Independent Pricing and Regulatory Tribunal

Review of Country Energy's Water Business
(Broken Hill)
Advice on Capital Expenditure

February 2009

Halcrow Pacific Pty Ltd

Figure 3.1 Historical and proposed capital expenditure

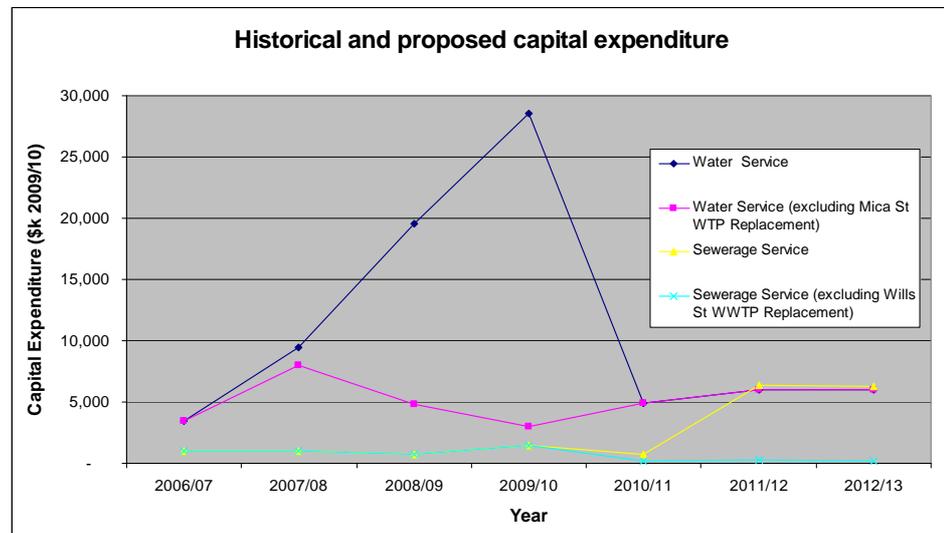
We note that there are inconsistencies between Table 8.1 of the SIR (Water capex by time) and Table 7.1 of the SIR (Capital expenditure by purpose). We have not sought to investigate the reasons for these differences.⁵ Our assessment of capital expenditure is based on Table 8.1 of the SIR.
